**BEFORE THE PUBLIC UTILITY COMMISSION
OF OREGON
LC 73**

2019 Integrated Resource Plan Update

Staff's Comments

Figure 1: PGE Annual MWH Sold, OPUC Stat Book

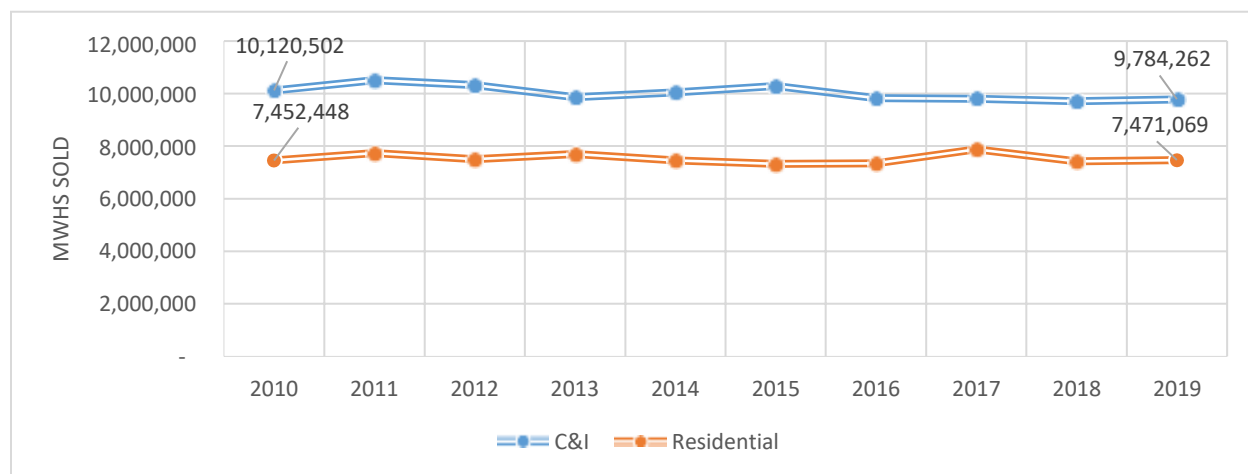
PGE’s IRP Update forecasts an increase in overall load growth from the acknowledged 2019 IRP. As shown in Figure 1, this increase is not necessarily in keeping with historic sales trends since 2010.

Staff looks forward to working with PGE between now and the 2022 IRP to better understand how recent developments have reversed historic trends in annual load growth.

Figure 2: PGE Annual MWH Sold for Resale, OPUC Stat Book

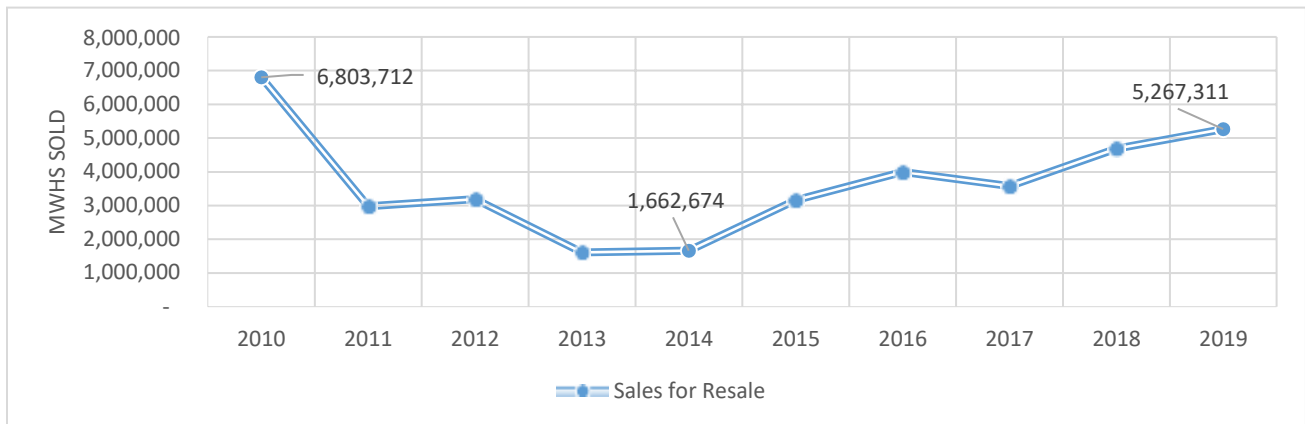
In PGE’s load forecast, related to capacity, in the 2050 reference case, summer peak demand increases by 124 MW due to the load forecast update.¹¹ Related to energy, PGE describes that, “in the outer years, the net market shortage increased, primarily due to the increased load forecast.”¹² Staff appreciates the clarifications in PGE’s response to DR 187 regarding the non-comparability of net market shortage in IRP planning and operational “sales for resale.” Regardless, as shown in Figure 2, the recent trend for PGE has been increasing sales to market.

Sales to market is only one part of an overall net position. Staff looks forward to working with PGE prior to the next IRP to understand the strategy and risks associated with resource acquisitions along with market purchases and sales to meet future load growth.

Figure 3: Comparison of Summer On-Peak Market Capacity Assumptions

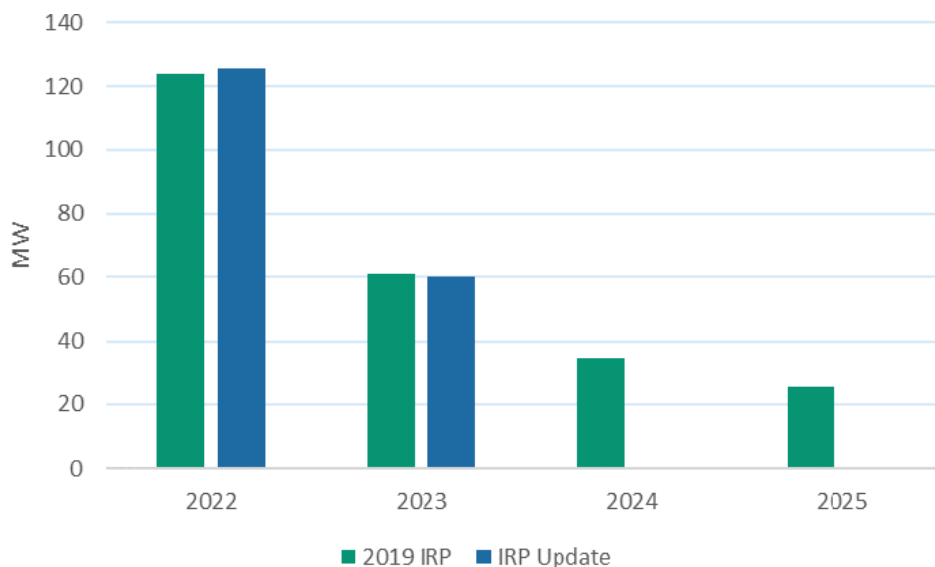
Figure 3, reproduced from IRP Update page 31, shows the decrease in summer, on-peak market capacity purchases available to PGE:

Staff’s IRP Final Comments recommended that “PGE should monitor and report on its market capacity assumptions as part of any RFP and in the 2021 update to LC 73, as market conditions may encourage the building of more generation resources regionally.”¹⁶ Indeed, it appears that regional resource retirements have increased the regional need for capacity, especially in the summer.

Figure 4: Comparison of Solar ELCC Curves

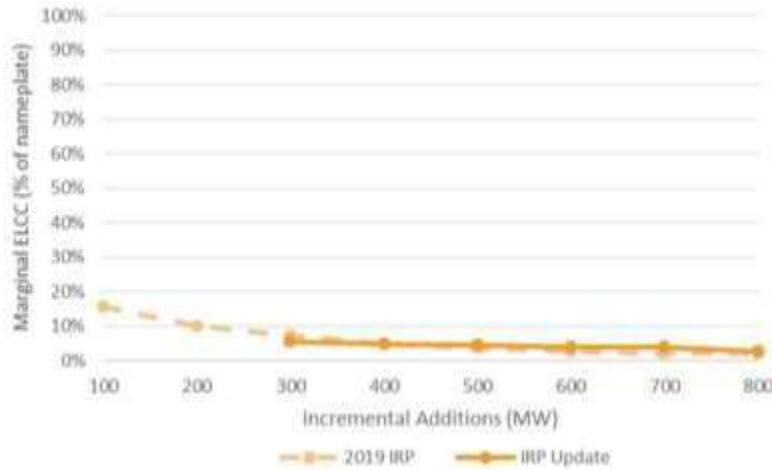
PGE has replaced its RECAP loss-of-load-probability model with the new Sequoia model that the Company developed internally. The Company uses its loss-of-load probability model to assess capacity need and to assign capacity contribution values to resources. Staff finds the Company’s process rationale for switching to the Sequoia model to reduce the need for outboard adjustments compelling. PGE also states that its Sequoia model introduces more sophisticated modeling of energy limited resources and interactive effects between resources. Simultaneous to the introduction of the Sequoia model, changes in the load and resource balance have changed capacity contributions. By running a baselining exercise, the Company has demonstrated that most of the changes in capacity contribution are due to the addition of similar resources on the system such that subsequent additions of resources with similar characteristics have decreased marginal benefits. For example, the declining marginal value of solar is shown as the downward sloping lines in Figure 4, which is reproduced from PGE’s response to Staff IR No. 189:

Only a small portion of the capacity contribution changes are attributable to the change from the RECAP model to the Sequoia model. Vetting the Sequoia model outputs is one of Staff’s top priorities for the next IRP. The ELCC values from the Sequoia model impact the avoided costs prices, so Staff is investigating the reasonableness of the ELCC changes. Broadly, this development is oddly juxtaposed to the IRP Update’s lack of on-peak summer market capacity in 2025. Staff looks forward to understanding the relationship, or lack thereof, between no summer, on-peak market capacity but a reduced ELCC – and thus capacity value – of new solar before the next IRP.

Figure 5: Reference case Loss-of-load expectation heatmap for 2025

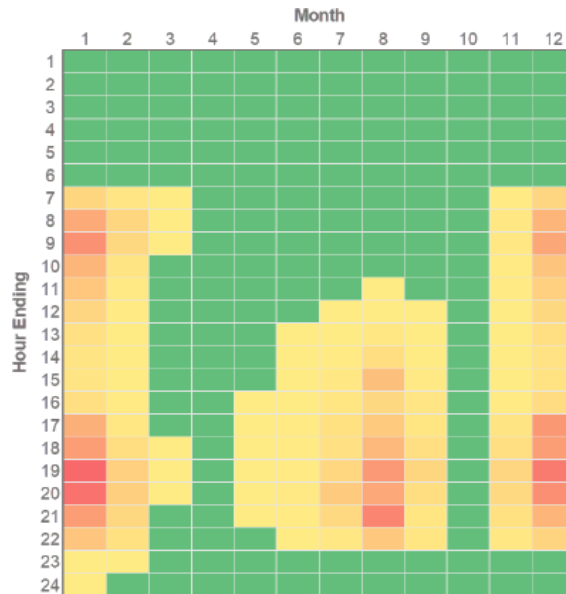
Staff is continuing to explore this change and appreciates that the Company provided Staff a narrative description of the capacity contribution changes in response to Staff IR 189. In Docket No. UM 2011, General Capacity Investigation, some stakeholders have expressed difficulty with the black-box nature of loss-of-load probability models like Sequoia. For example, visually looking at PGE’s updated loss-of-load expectation heatmap in Figure 5, reproduced from IRP Update page 36, shows that there remains visual expectations of loss-of-load during solar generation daylight hours:

PGE begins to justify the apparent visual usefulness of solar capacity in contrast to its low ELCC value by noting that “while the loss-of-load expectation heatmaps can be useful for understanding the hourly and seasonal nature of the probability of loss of load events, the heatmaps are limited in the information that they provide... the shading does not indicate information about the quantity of capacity needed.”²⁰ Nonetheless, Staff remains concerned as, for example, PGE’s computation is drastically lower than Consultant E3’s figure in IRP External Study E, which is reproduced as Figure 6 (E3’s study identifies the Northwest Power and Conservation Council as the source for the values):

Figure 6: Seasonal ELCC for wind and solar resources as a fraction of their nameplate capacity

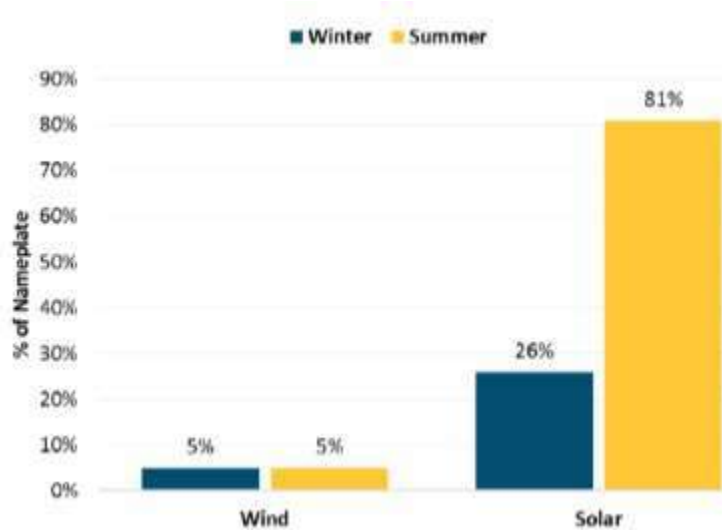
As described above, vetting the Sequoia model outputs is one of Staff’s top priorities. Additionally, the information requests submitted by Renewable Energy Coalition (REC) to PGE will help Staff explore the issue. Staff specifically desires to explore further whether PGE’s capacity contribution values are dependent on its choice of the reference year 2025 for its modeling.²¹

Figure 7: Mixed full clean action plan window resource additions

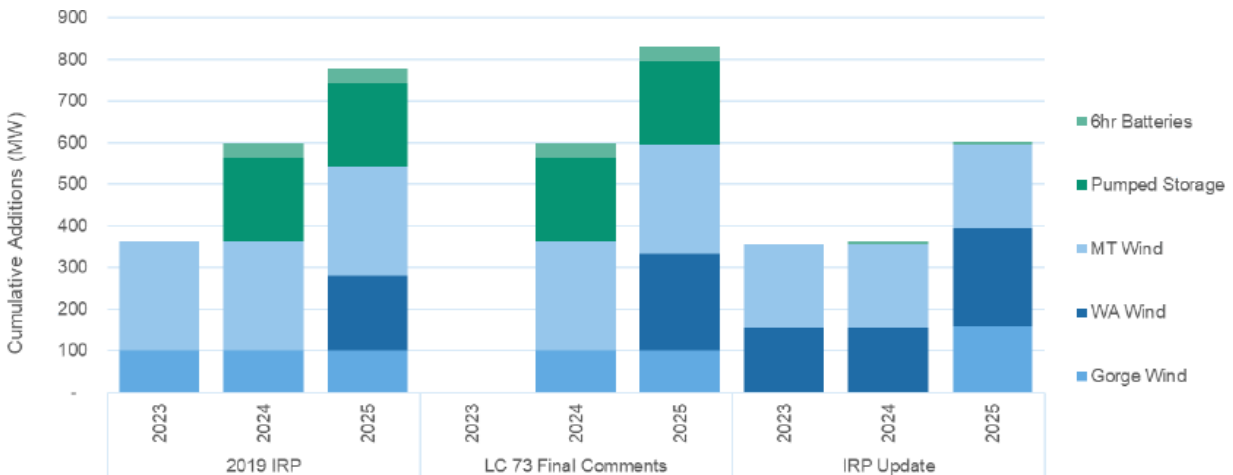
PGE’s preferred portfolio has significantly changed since its acknowledged IRP, as shown in Figure 7, which is reproduced from IRP Update page 52:

To understand the significant changes to the preferred portfolio, Staff met with PGE on February 23, 2021. PGE talked with Staff to provide an overview of the sensitivity of the preferred portfolio to production tax credit (PTC) changes. The significant change is to replace procurement of batteries and storage with wind in the near term. In an information request to PGE, Staff asked: if the PTC is extended again, is the optimal renewable addition delayed? In its response, PGE states that “the availability of the PTCs is an influential component in this determination [of the optimal type, size, and timing of all resource additions].”²² Staff expresses a concern that because the ELCC of storage is greater than that of wind, the Company is obtaining less capacity per MW of nameplate resource size. Staff recommends that this issue be addressed in coordination with review of PGE’s RFP, specifically, if storage and battery bid prices are lower than assumed in PGE’s IRP, then procurement of storage and batteries might again become preferred. Staff is also concerned about the risk of potential future capacity shortfalls in the region. Staff is working to understand how PGE’s PPA with the Douglas County PUD affects the portfolio optimization.
